**WHITE LAKE TOWNSHIP
ZONING BOARD OF APPEALS**

**REPORT OF THE
COMMUNITY DEVELOPMENT DEPARTMENT**

Agenda item: 8d

RE: Gateway Crossing
Preliminary Site Plan and Special Land Uses – Review #4

DRAWN BY: CMS
CHECKED BY: VW, JR
IN CHARGE: VW, JMR
SHEET NAME:
PRELIMINARY ELEVATIONS

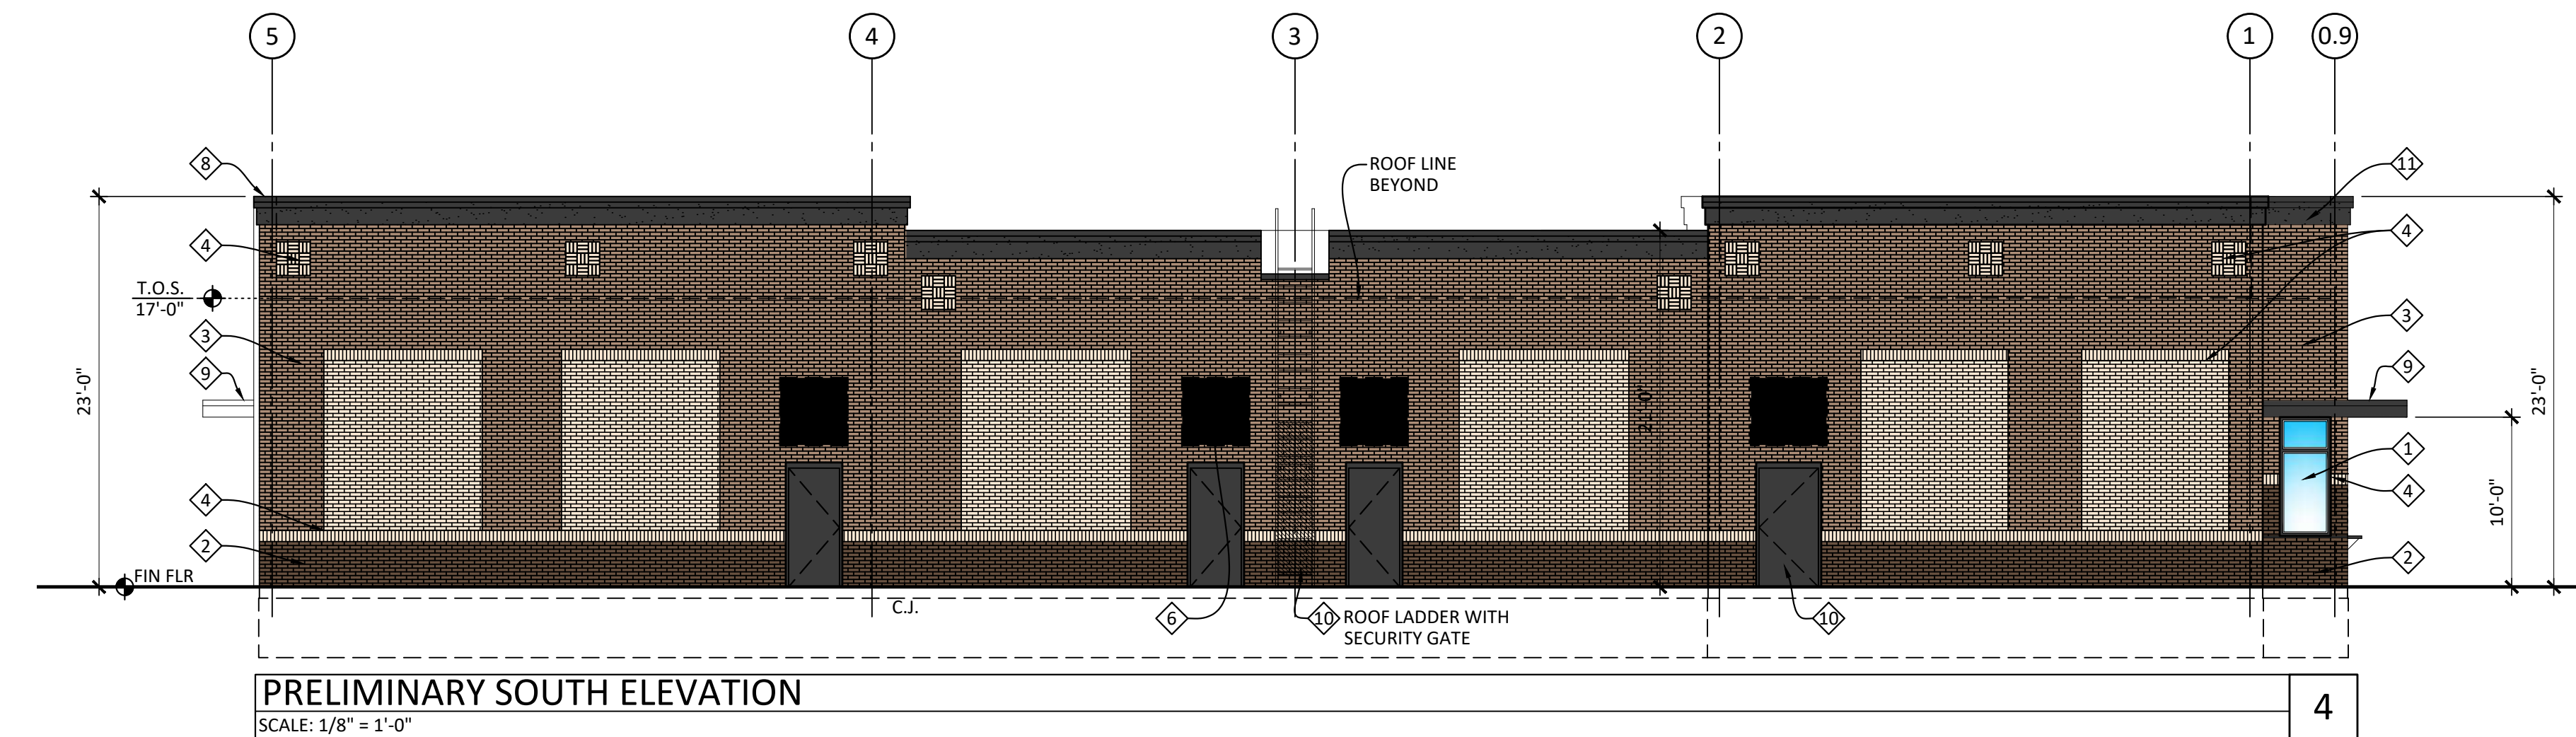
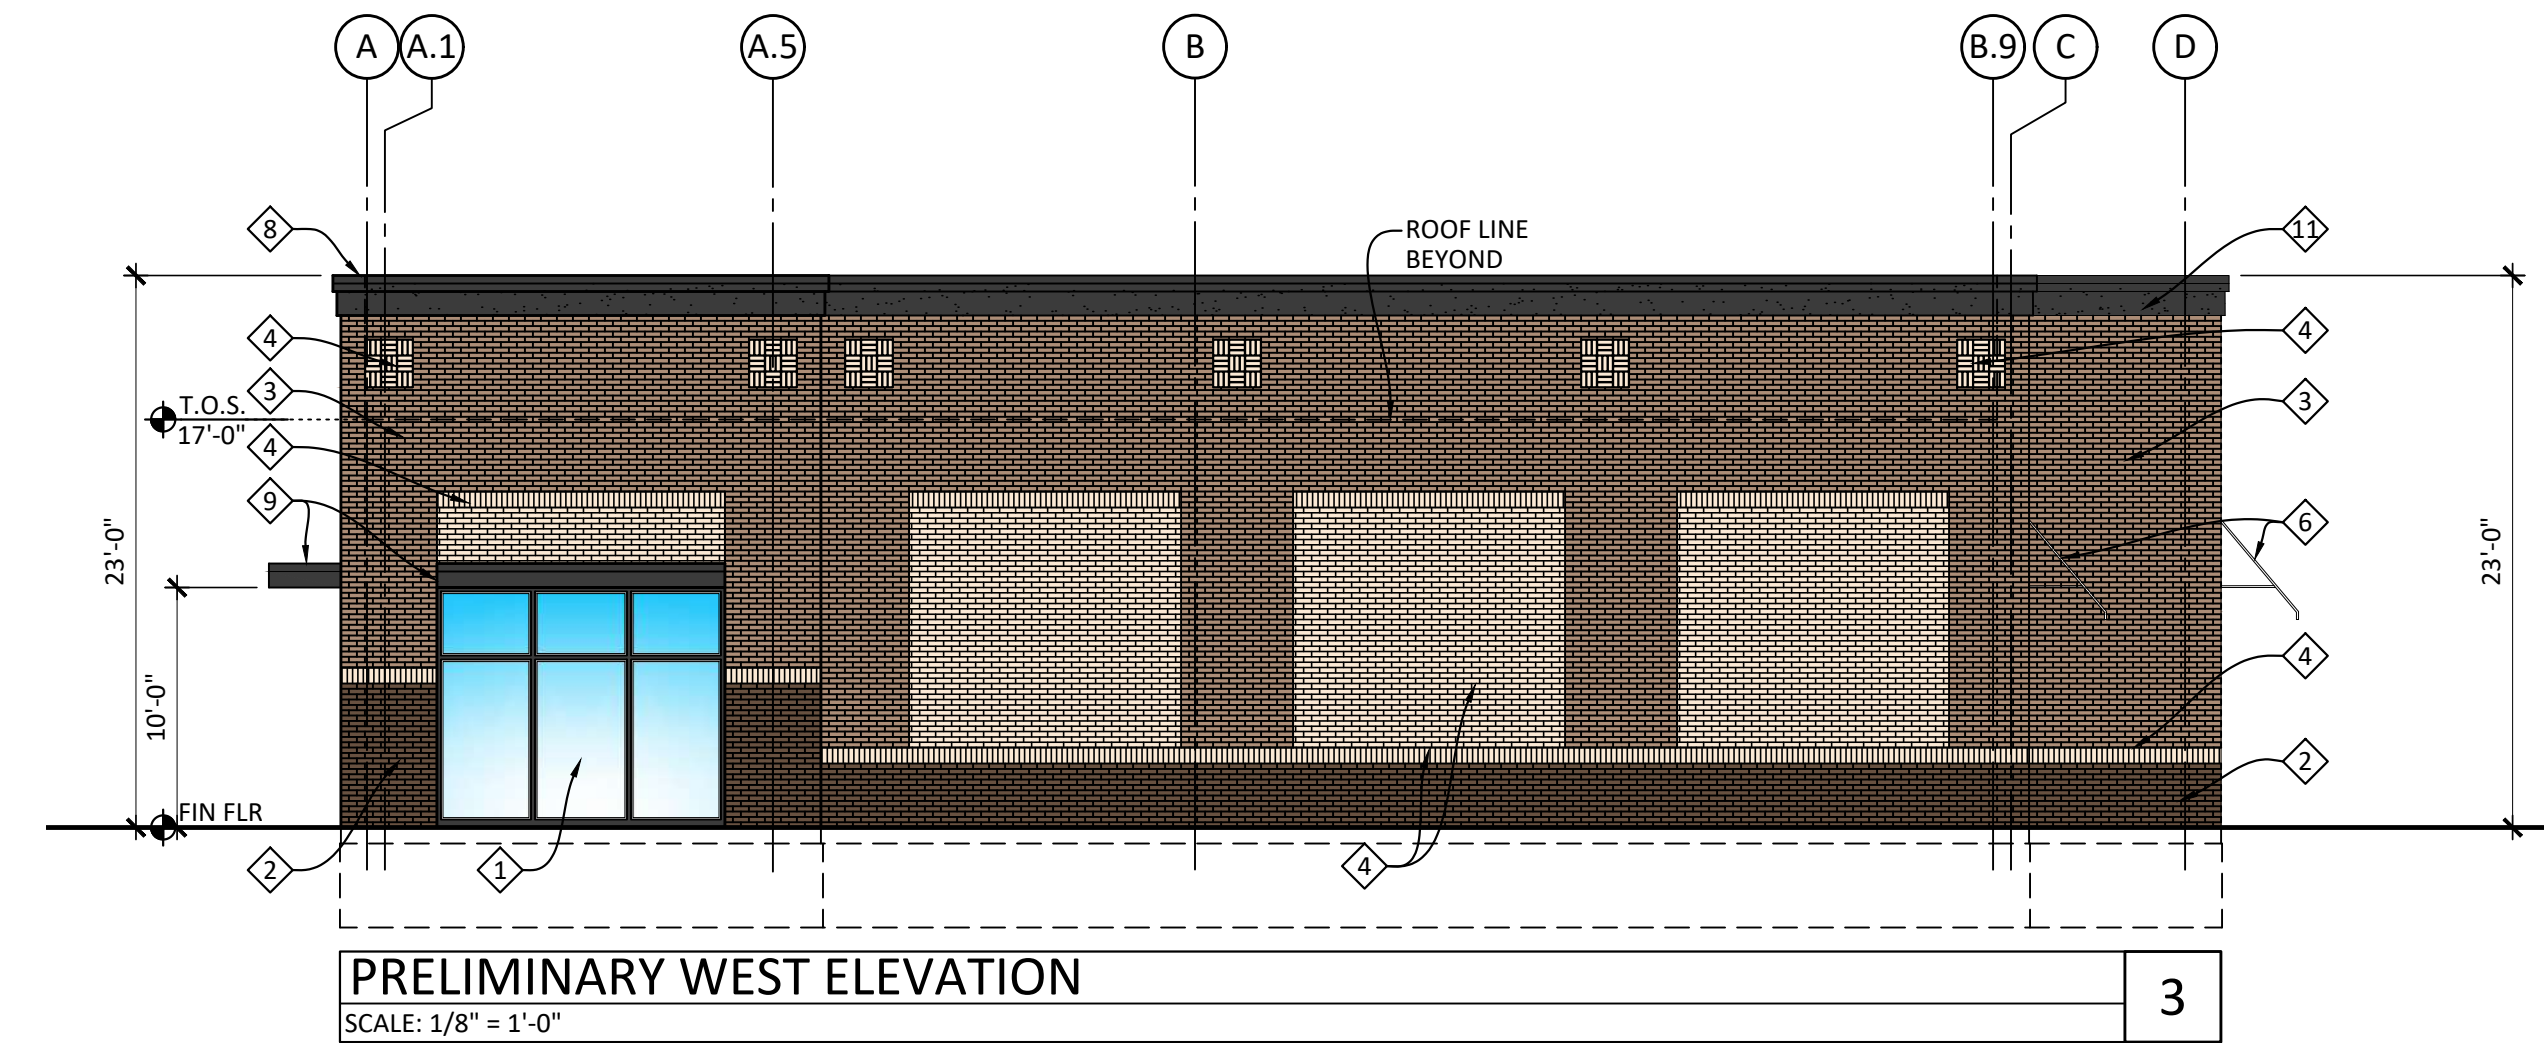
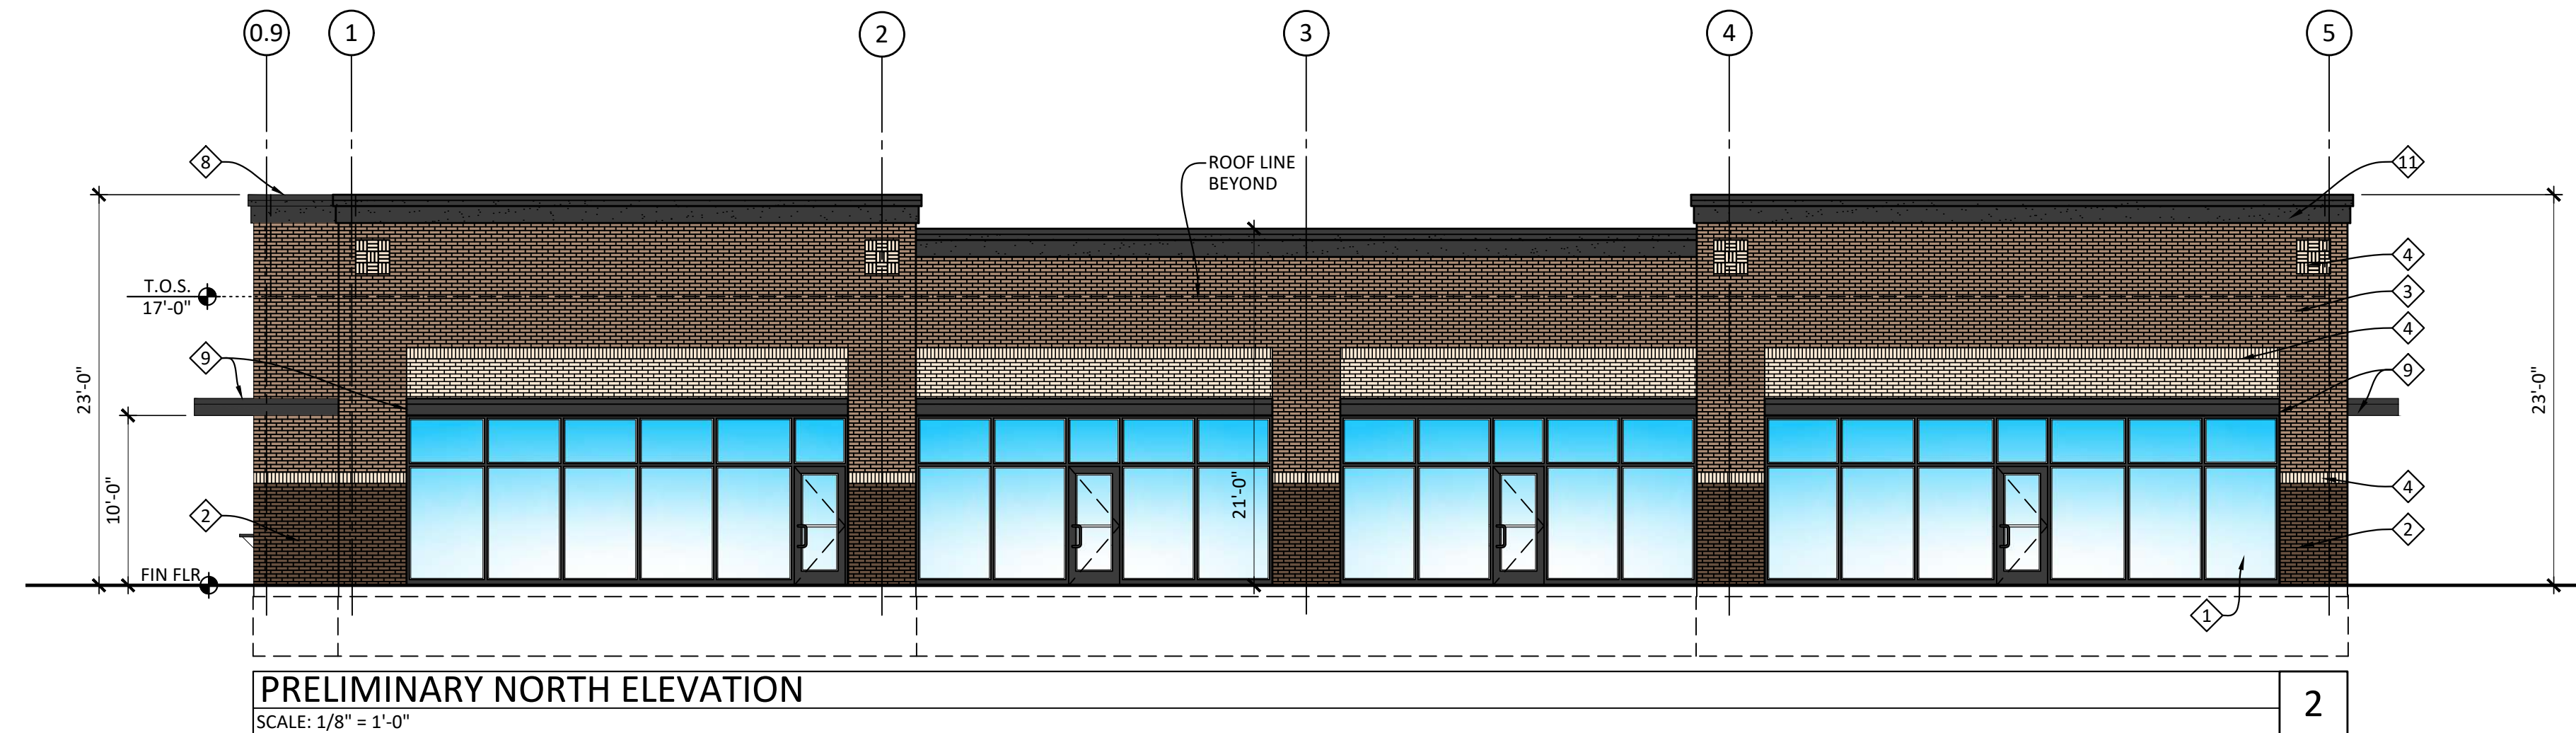
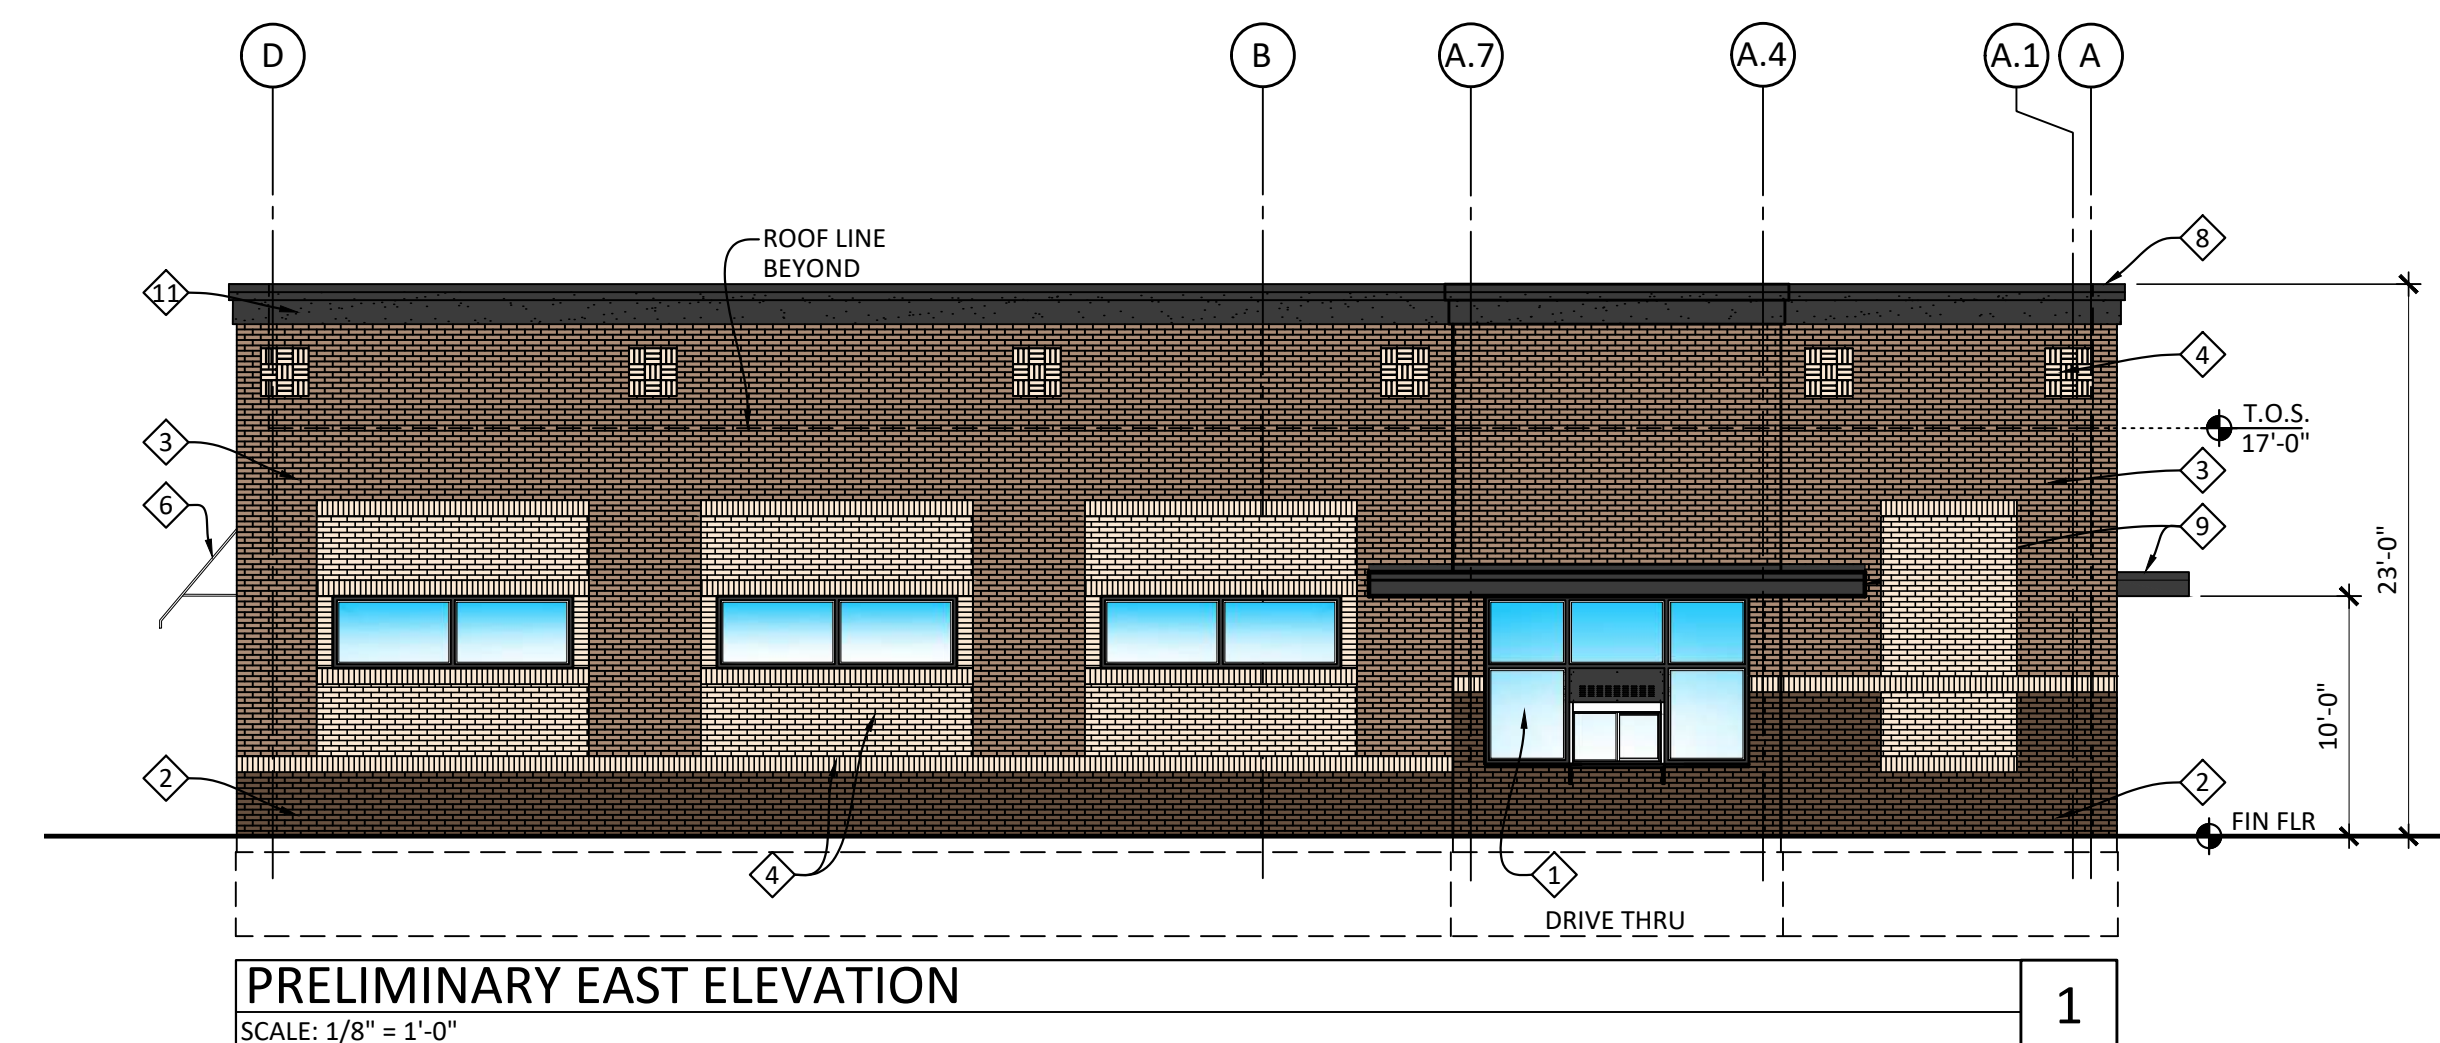
While building materials will be reviewed in detail at final site plan, the Applicant should be aware of the Township's architectural character requirements. EFIS, fiber cement siding, and hardie panel are not considered high-quality materials. **Seventy (70) percent of all elevations of both buildings should be covered with some combination of brick or stone or glass.** (Comment outstanding. The building is unattractive in appearance, and the fiber cement paneling and siding are substandard materials. All sides of the building will be visible from adjacent roads and must be comprised of high-quality materials. Also, a brown/tan/taupe color scheme should be utilized on the building as opposed to dark grey, light grey, and black). (Comment addressed. The building materials have been revised to include almost all brick veneer with a light, medium, and dark brown color scheme). **Furthermore, all buildings shall have windows at eye level covering at least 30 percent of the front facade (north and east elevations of the buildings). Calculations for window coverage on the front facades shall be provided on the elevations at final site plan.** (Comment remains as a notation. This requirement was acknowledged by the Applicant's engineer in the response letter provided to the first review). While front facade window coverage calculations are not provided at this time, it appears the north elevation meets the 30% requirement. However, the east elevation does not meet the 30% requirement; if the east elevation is not updated to provide the required window coverage, a variance must be requested from the Zoning Board of Appeals. (Glass coverage calculations have been added to the preliminary elevations. The required window coverage is provided on the north elevation, but a variance is required on the east elevation as only 9.27% window coverage is proposed. The required variance has been added to the variance list on Sheet 4 of the plan set).
